AXOD/AXODE (AX4S) UPDATE HANDBOOK

INTRODUCTION

This updated version of the AXOD "Update Handbook" will also cover the changes that occurred in the 1991 model year, when electronic controls were adapted to the AXOD transaxle, making it an AXODE, and now called an AX4S transaxle. We have included the changes on the AX4S transaxle up through and including model year 2002.

Figure 89

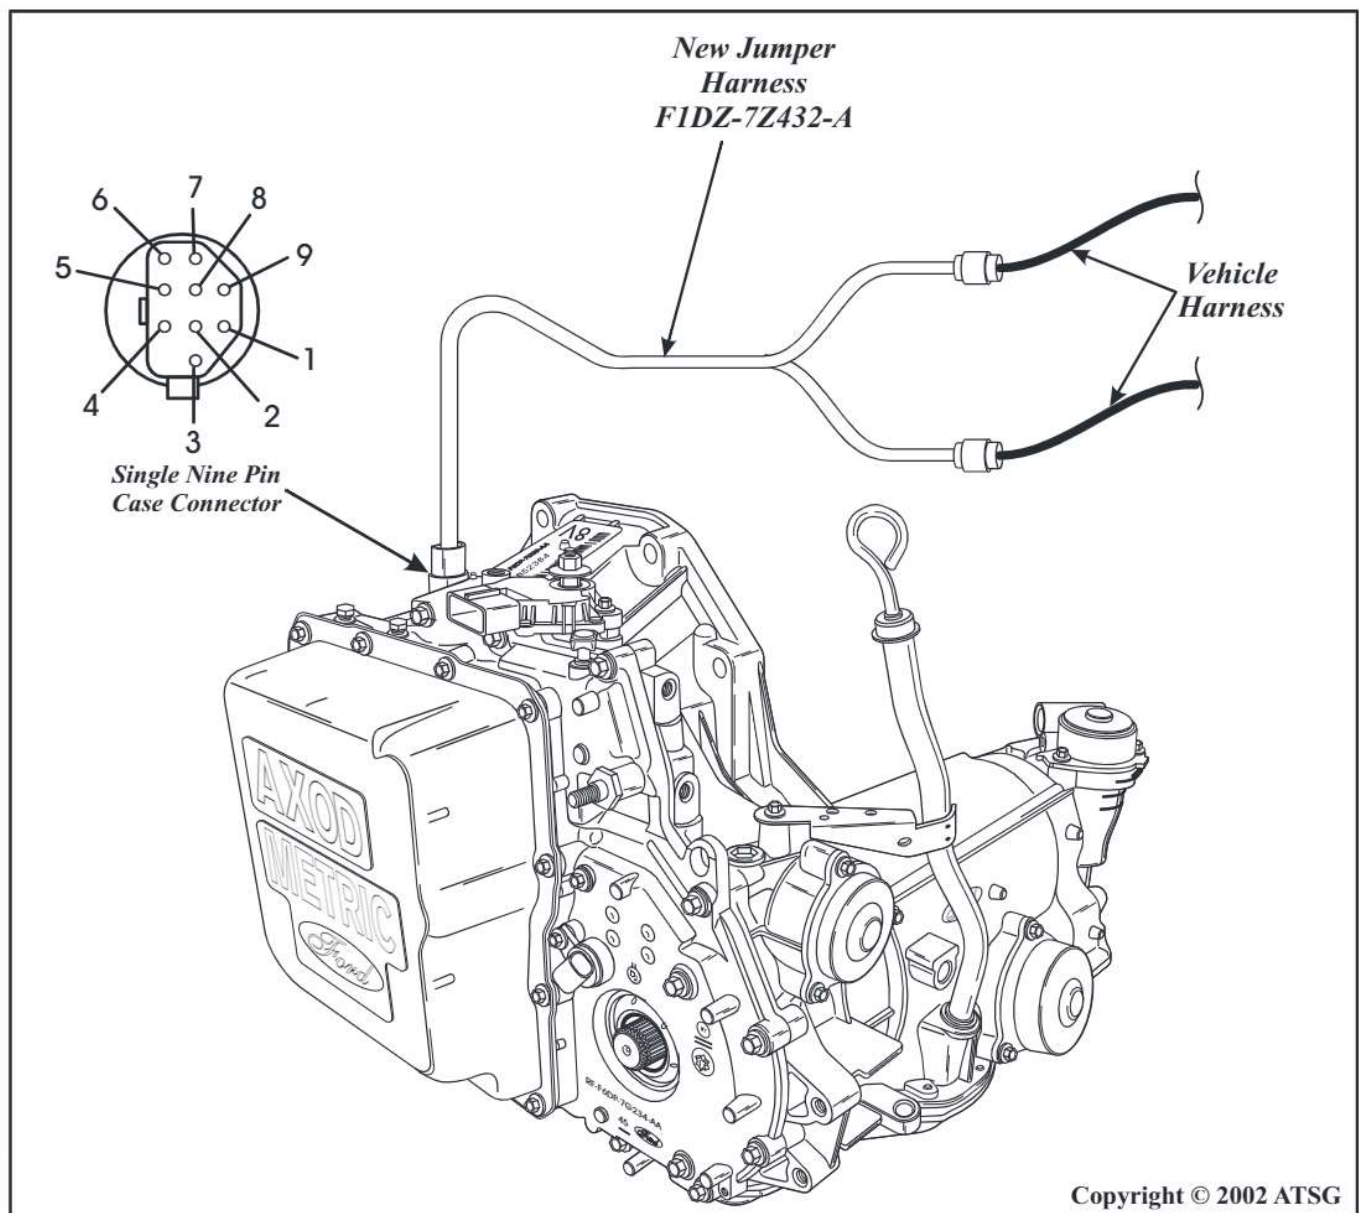
If service requires replacement of the chain cover on a 1991 or 1992 AXODE transaxle, it must be replaced with a 1993 design level AXODE chain cover assembly kit. The 1993-Up design level chain cover has only one nine pin external electrical connector located at the top of the transaxle as shown in Figure 89, and the previous side connector, as shown in Figure 88, has been eliminated. This requires a new "Y" harness, which is included in the service package "Kit", to make it compatible with 91-92 vehicles. The new design "Y" harness is also illustrated in Figure 89.

Figure 94

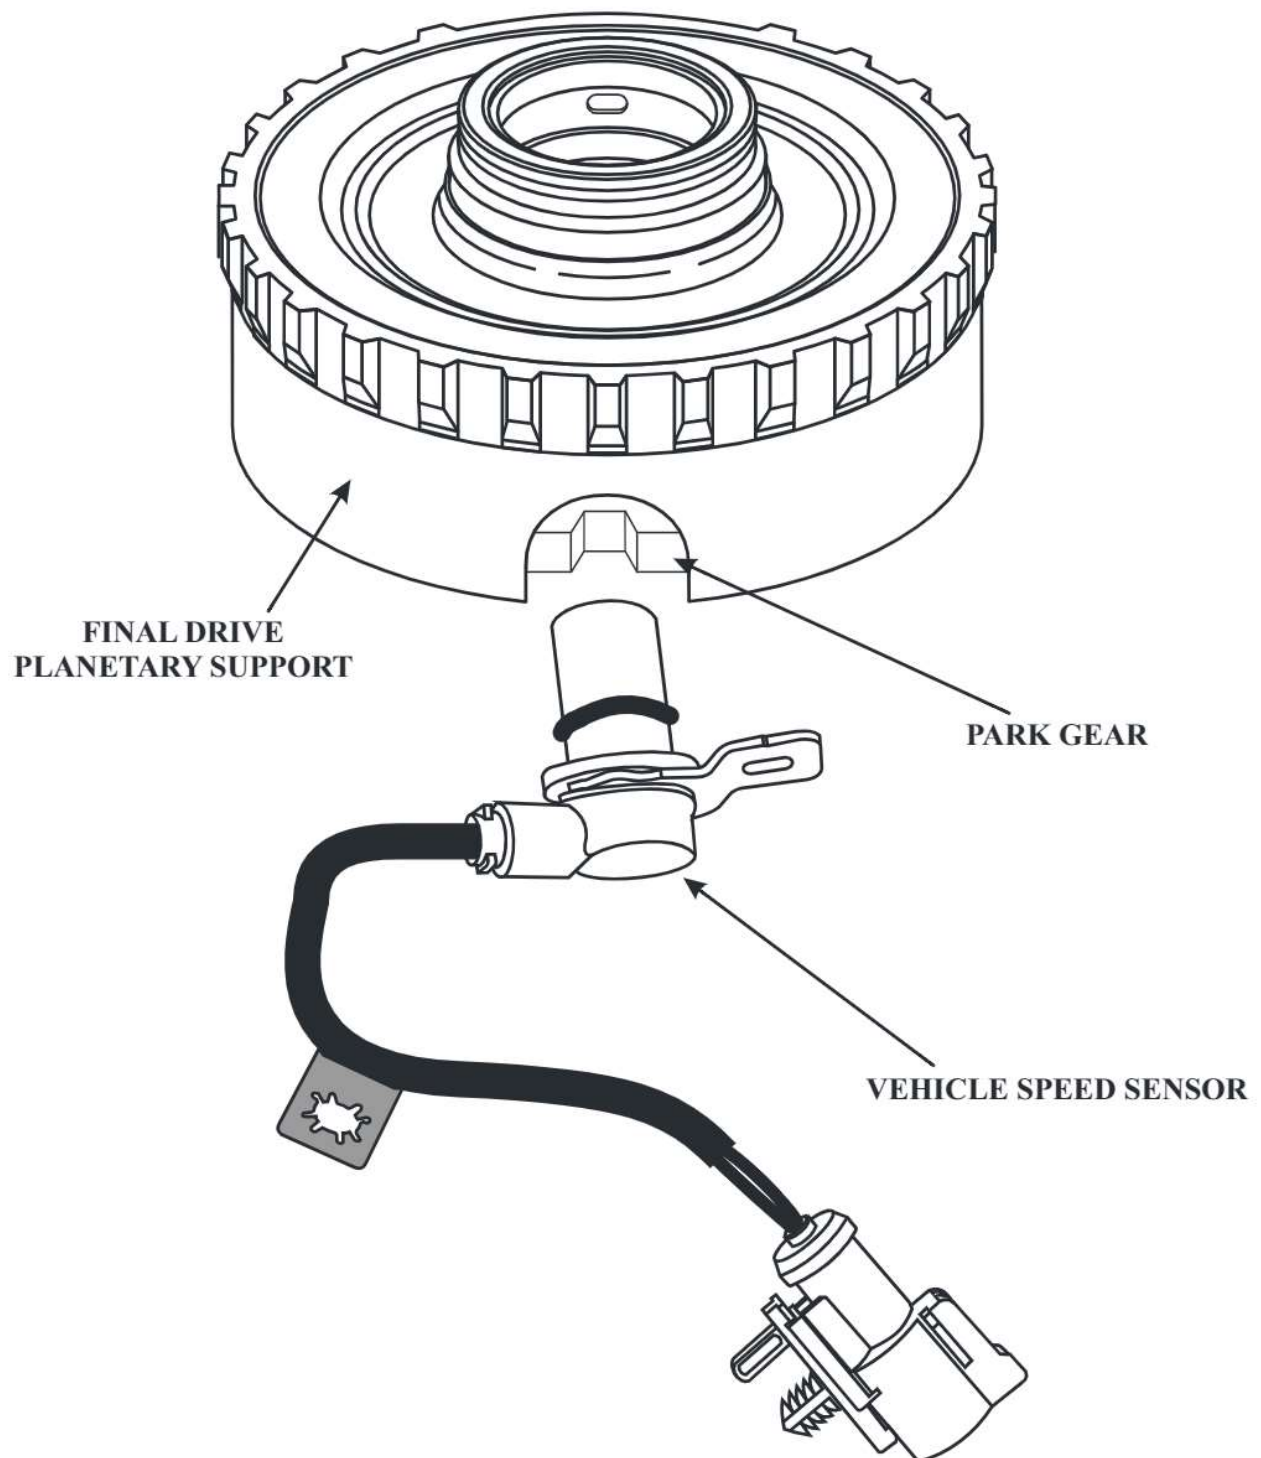
- (1) TRANSAXLE CASE - Changed to accommodate mounting the new design speed sensor so that it is in line with the planetary support and the park gear.
- (2) FINAL DRIVE SUPPORT - Changed to accommodate mounting the new design speed sensor and now has a **"cut out"** for the speed sensor to look through at the park gear, as shown in Figure 94.

Figure 97

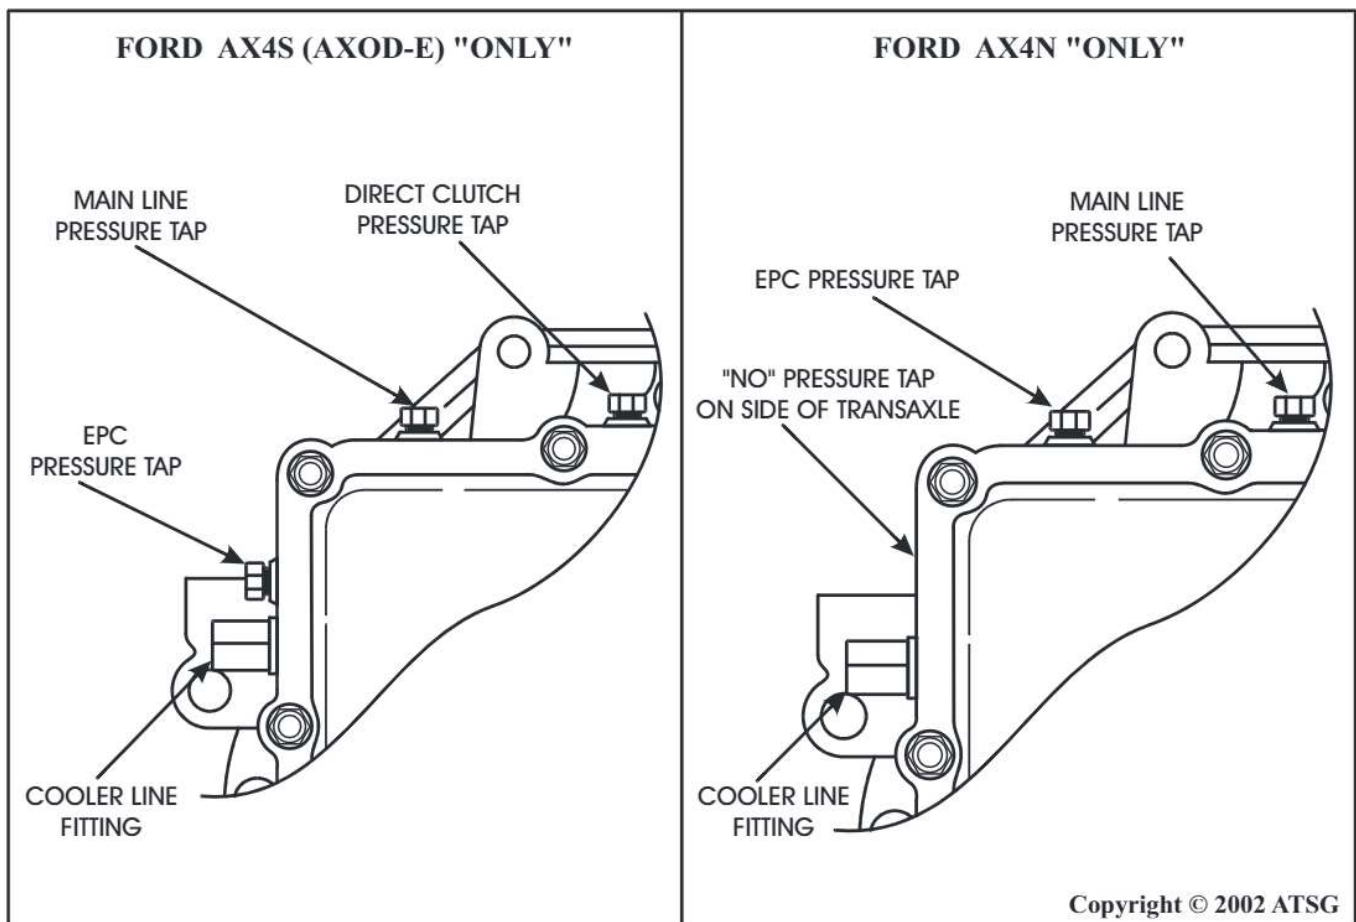
Most technical manuals, including Ford Motor Company manuals, have the pressure tap locations identified wrong. Use this page to correct your manuals at the shop for the correct pressure tap locations.

Refer to Figure 97 for the AX4S (AXOD-E) transaxle pressure tap locations.

Figure 98

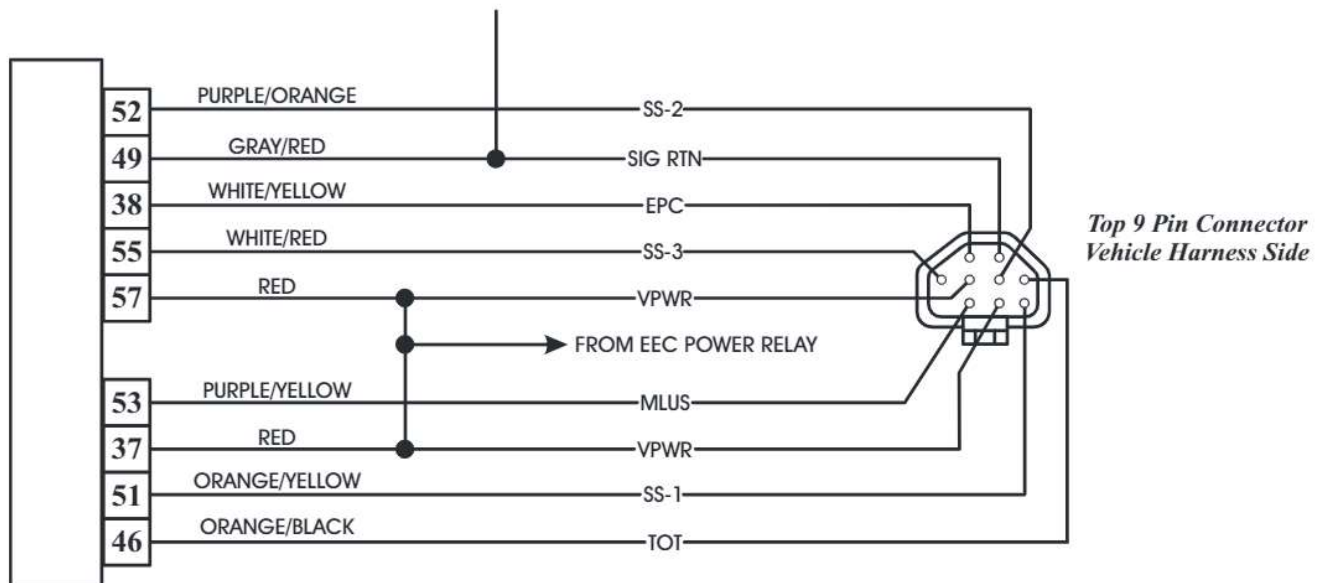
To begin the EPC circuit current draw test, the EPC ground wire that runs from the computer to the transaxle case connector must be located, and the external wire color will be White with a Yellow tracer on both versions, as shown in Figure 98. On 1991-1992 model vehicles the wire will be found in the top case connector and comes from pin number 38 on the computer. On 1993-UP vehicles there is only one case connector and the wire still comes from pin number 38 on the computer. Refer to Figure 98.

Figure 102

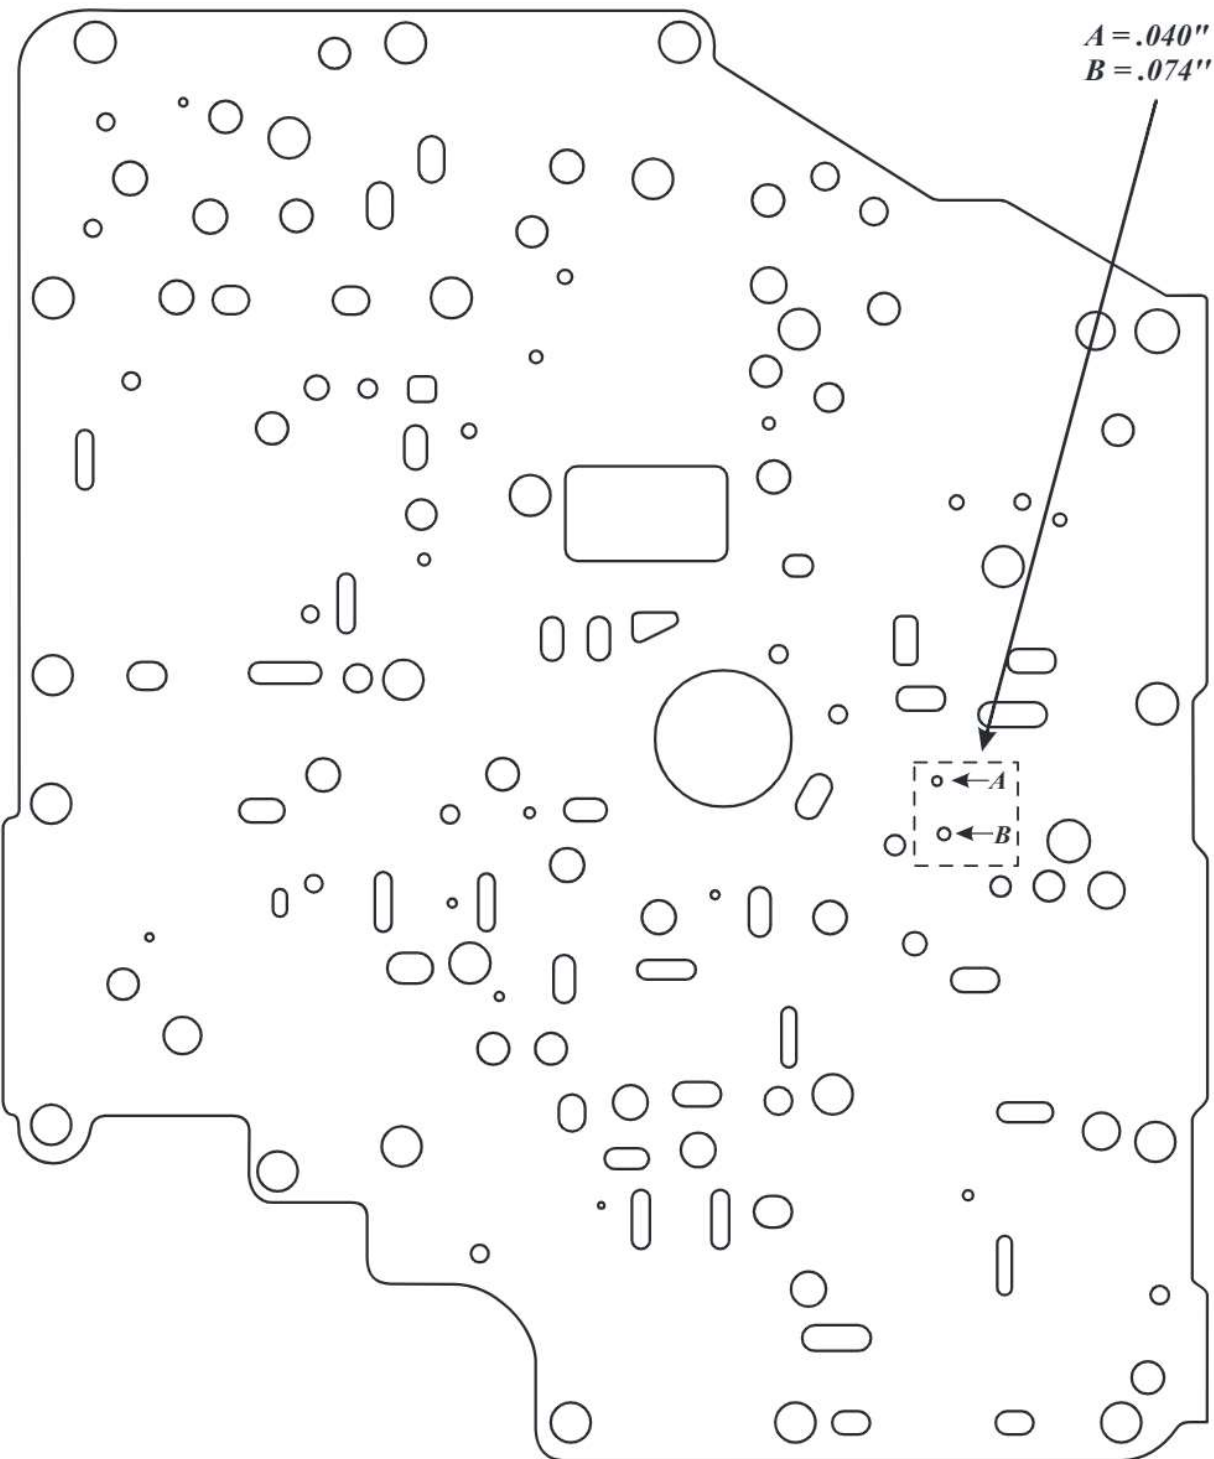
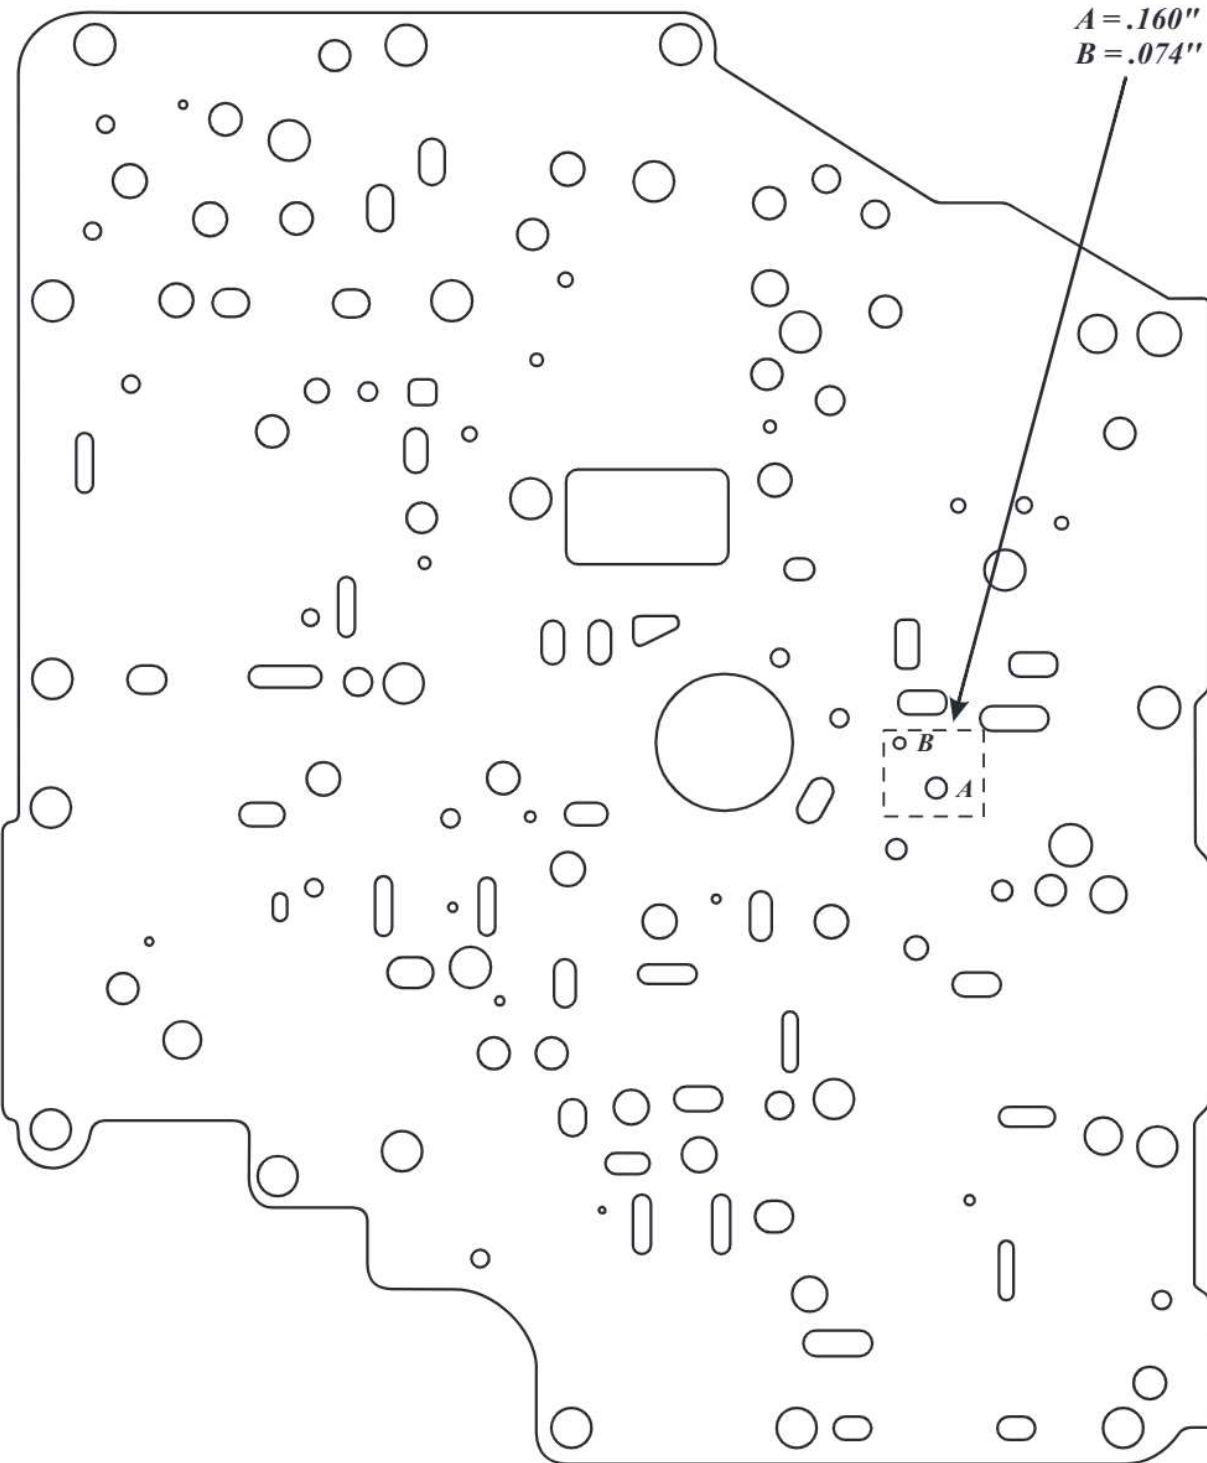
COMPLAINT: Some 1995-Up Ford Windstar Vans may exhibit a harsh 1-2 upshift, either before and/or after overhaul of the transaxle. Some 1995-Up Ford Taurus, Mercury Sable or Lincoln Continental may exhibit a soft or flare on the 1-2 upshift either before or after overhaul.

CAUSE: The cause may be, a valve body spacer plate designed for the Taurus, Sable, Continental passenger car family, has been installed on a Windstar Van, creating a harsh 1-2 upshift. If the Windstar Van valve body spacer plate, is installed on the Taurus, Sable, Continental family of vehicles, the result will be a soft or flared 1-2 upshift. ***Obviously these two spacer plates are different.*** Refer to Figures 101 and 102, using the two holes over the 1-2 capacity modulator valve area, for identification.

CORRECTION: Install the proper valve body spacer plate for the Ford family that you happen to be servicing at this time. Refer to the illustration in Figure 101 to identify the valve body spacer plate for the Windstar Van. Refer to the illustration in Figure 102 to identify the valve body spacer plate for the Taurus, Sable and Continental family.

Figure 103

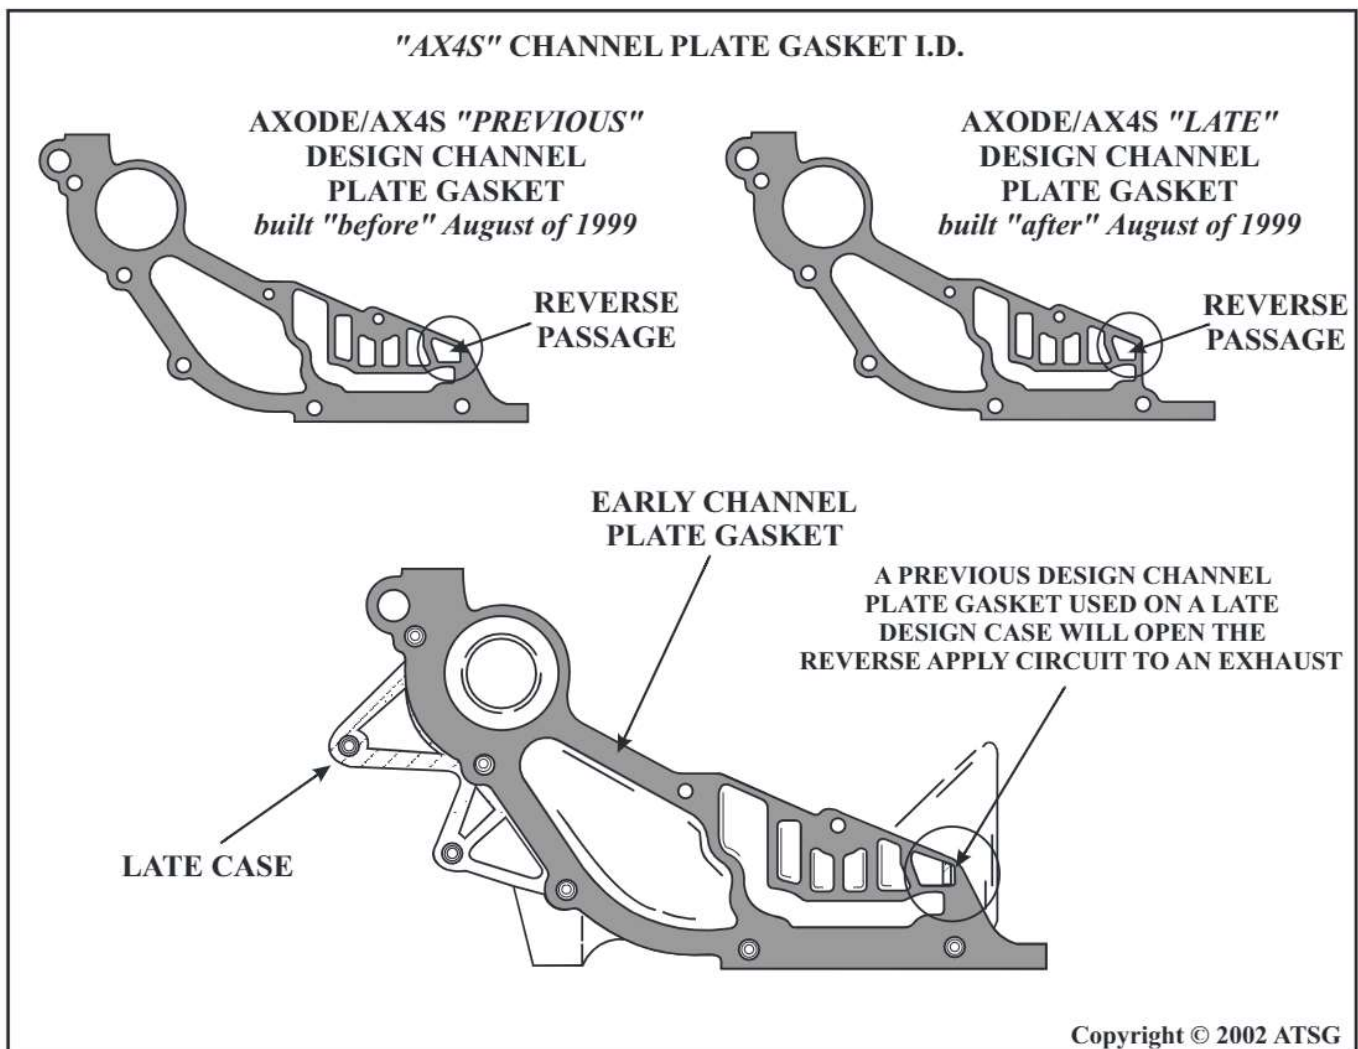
CAUSE: The cause may be, that the *Previous Design* Channel Plate Gasket, was used on a *Late Design* case as shown in Figure 103. When this happens, Reverse apply pressure will be exhausted back into the case because of the gasket hanging over the case casting.

CORRECTION: AX4S-Refer to Figure 103 to identify the correct Channel Plate Gasket for the application of vehicle you are working on.
AX4N-Refer to Figure 104 to identify the correct Channel Plate Gasket for the application of vehicle you are working on.
